# ***Errata to*** **2007 Edition** **National Electrical Safety Code®**

*Correction Sheet*  
**Issued 14 May 2007**

**Table 232-1—Vertical clearance of wires, conductors, and cables above ground,  
roadway, rail, or water surfaces**

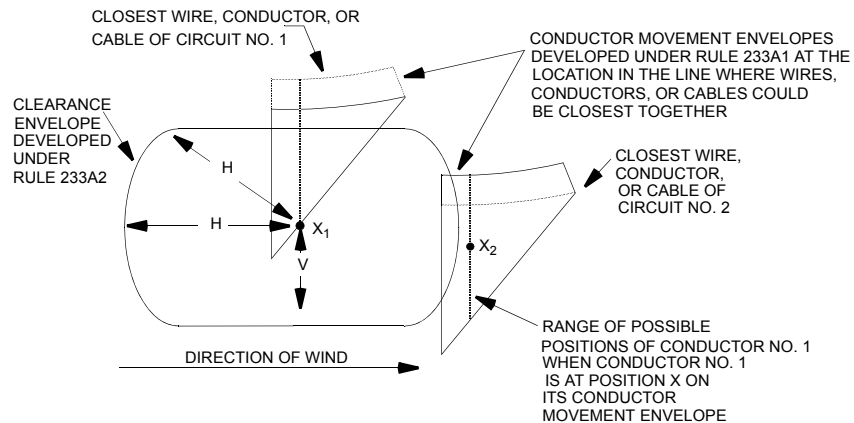
**Page 92:** There is an error in Table 232-1 (ft). The footnote that appears in the first column of the fourth row should be “<sup>(26)</sup>” and not “<sup>(29)</sup>.”

4. Other land traversed by vehicles, such as cultivated, grazing, forest, orchards, etc. <sup>(26)</sup>	15.5	16.0	16.5	18.5	—	—
--	------	------	------	------	---	---

**Example 1**

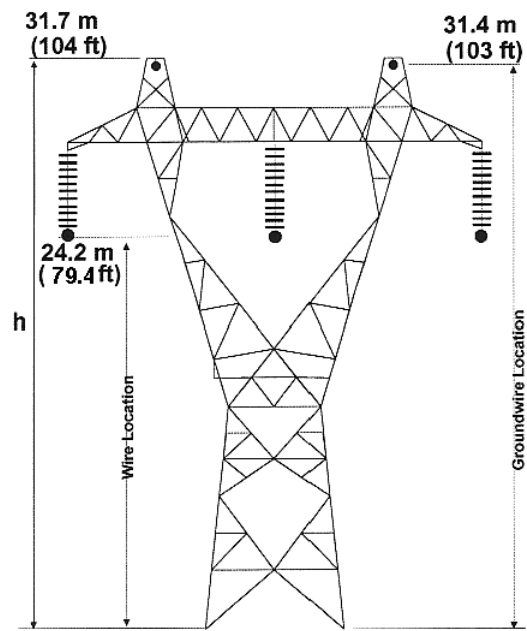
**Page 290:** There is an error in the figure in Example 1 of Appendix C. The height of the “Wire Location” should be “(79.4 ft)” and not “(72.5 ft).”
